# ADDENDUM #1

Reference: HVAC Upgrade – Phase II Bunnell Dmitrich Athletic Center (BDAC)  
College of Eastern Utah – Price, Utah  
DFCM Project No. 06162610

**ADDENDUM NO. # 1**

**DATE:** March 19, 2008  
**PROJECT NO:** 6203  
**PROJECT:** CEU BDAC Phase II

**SD-01  
MP-6.1**

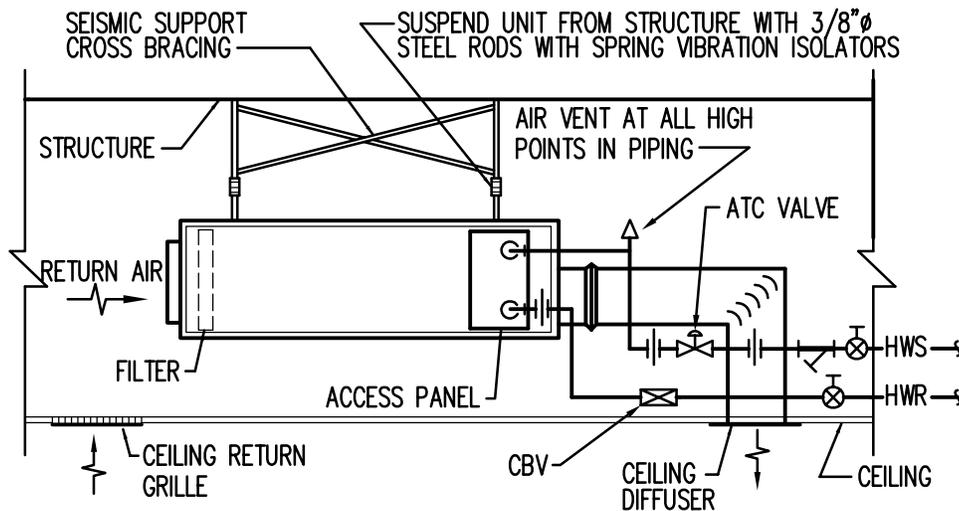
SHEET - MP-6.1 – Details for Fan Coil Unit and VAV boxes have been added. Please see attached details.
